## PREPARED FOR THE URBAN DESIGN COMMISSION AND PLAN COMMISSION

**Project Address:** 4198 Nakoosa Trail  
**Application Type:** Demolition Permit and Conditional Use  
**Legistar File ID #** [34918](#)  
**Prepared By:** Timothy M. Parks, Planning Division  
Report includes comments from other City agencies, as noted.

**Requested Actions:** Approval of a demolition permit and conditional use to allow demolition of a street-facing facade of a large retail development at 4198 Nakoosa Trail and construction of an addition to the store with a vehicle access sales and service window, and consideration of a conditional use for outdoor sales and display areas for the expanded store.

PROPOSED WAL-MART SUPERCENTER NO. 2335-11  
CITY OF MADISON, DANE COUNTY, WISCONSIN  
OVERALL LANDSCAPE PLAN

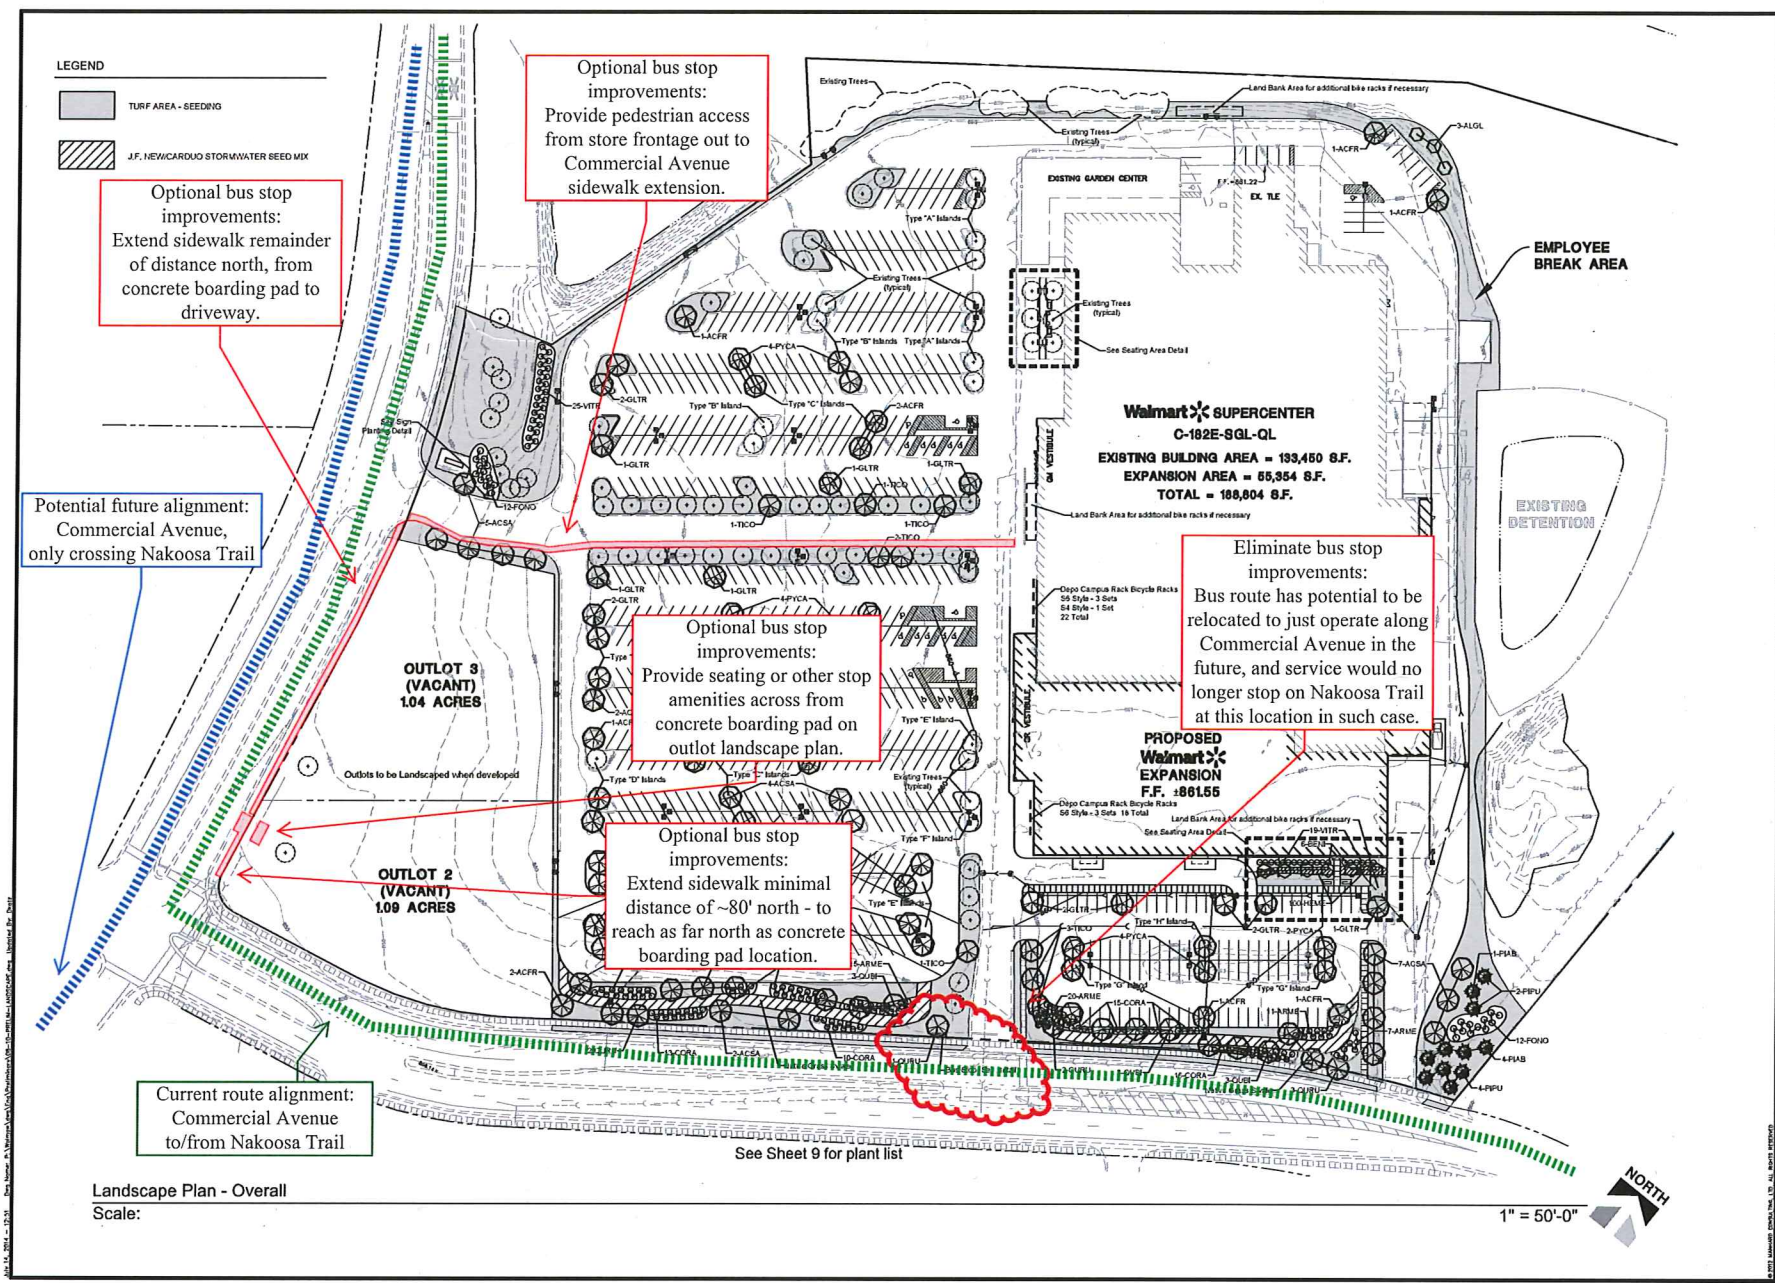
28. Provide landscape plans pursuant to MGO Section 28.142(3), Landscape Plan and Design Standards. Landscape plans for zoning lots greater than 10,000 square feet in size must be prepared by a registered landscape architect. Provide details of screening pursuant to MGO Section 28.142(9) and 28.142(11)(d).
